UNITED STATES PATENT AND TRADEMARK OFFICE

APPLICATION NO.	FILING DATE	FIRST NAMED INVENTOR	ATTORNEY DOCKET NO.	CONFIRMATION NO.
10/589,317	08/14/2006	Bernhard Moser	3635	6836
7590	02/05/2009		EXAMINER	
Striker Striker & Stenby 103 East Neck Road Huntington, NY 11743			FULLER, ROBERT EDWARD	
			ART UNIT	PAPER NUMBER
			3676	
			MAIL DATE	DELIVERY MODE
			02/05/2009	PAPER

Office Action Summary	Application No.	Applicant(s)	
	10/589,317	MOSER ET AL.	
	Examiner	Art Unit	
	ROBERT E. FULLER	3676

DETAILED ACTION

Figure 1 - Huber as it relates to the claimed invention.

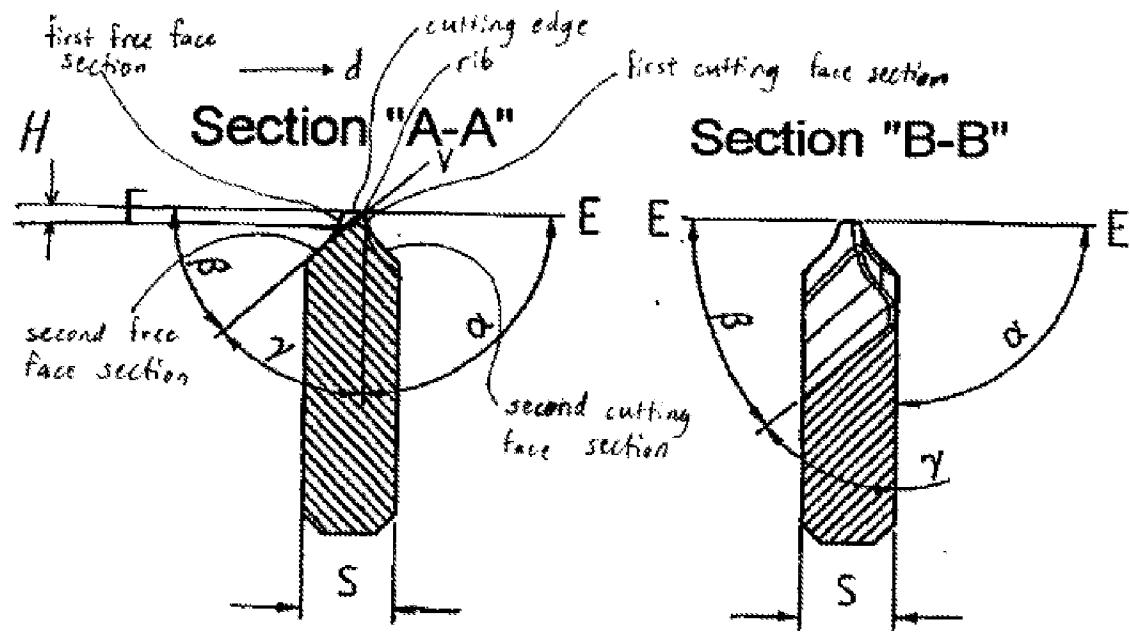
With regard to claim 1, Huber discloses a drilling tool (1), especially for percussion drilling, which comprises a cutting element (2) that is configured as a plate or head and that has at least one cutting edge (3) defined by a cutting face (5) and a free face (7), wherein the cutting edge is associated with a first free face section (see Figure 1 below) which lies in a cutting plane and is limited by a convex bulge or a convex polygon outline (see Figure 1 below), and wherein the vertical height of a rib (see Figure 1 below) defined by the first free face section and an associated first cutting face section appears to range from .1 mm to 1.0 mm. Note that, with respect to the above rejection under 35 U.S.C. 112, the claims are being examined as best understood by the examiner.

With regard to claim 5, a second free face section follows the first free face section (see Exhibit A).

With regard to claim 6, Huber discloses a second free face section (see Exhibit A).

With regard to claim 7, an extension (see "V" in Exhibit A) extends in a direction of rotation (see "d" in Exhibit A) of the drilling tool through the cutting element below the cutting edge.

Figure 2 - Dunn et al. as it relates to the claimed invention.

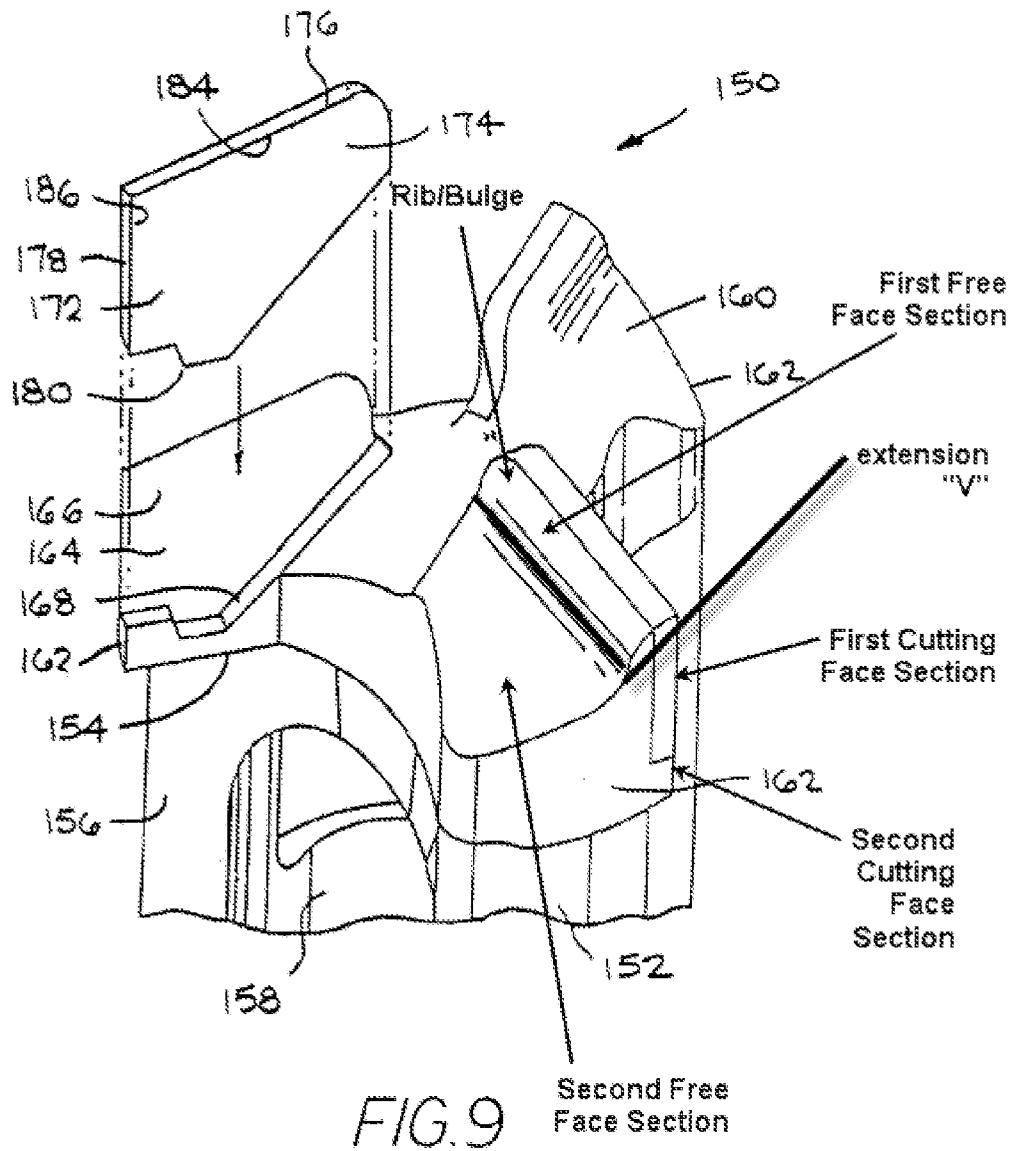
With regard to claim 1, Dunn discloses a drilling tool (150) for percussion drilling, which comprises a cutting element (162) that is configured as a plate or head and that has at least one cutting edge (184) defined by a cutting face (174) and a free face (160), wherein the cutting edge is associated with a first free face section (see Figure 1 below) which lies in a cutting plane, wherein the cutting plane (CP) is cut at a right angle to the cutting edge and is limited by a convex bulge (see Figure 2 below) or a convex polygon outline, and wherein the vertical height (H) of a rib (see Figure 2 below) defined by the first free face section and an associated first cutting face section (see Figure 2 below) ranges from 0.1 mm to 1.0 mm.

With regard to the ranges in both claims 1 and 2, the size of the rib falls within the claimed range, as the rib is only defined by a first free face section and an associated first cutting face section, and examiner can assign where the first free face begins in Dunn. Therefore, the first free face begins 0.5 mm below the cutting edge.

With regard to claims 5 and 6, Dunn discloses a second free face section and a second cutting face section (see Figure 2 below).

With regard to claim 7, an extension (see "V" in Figure 2 below) of the second free face section extends in a direction of rotation of the drilling tool through the cutting element below the cutting edge.
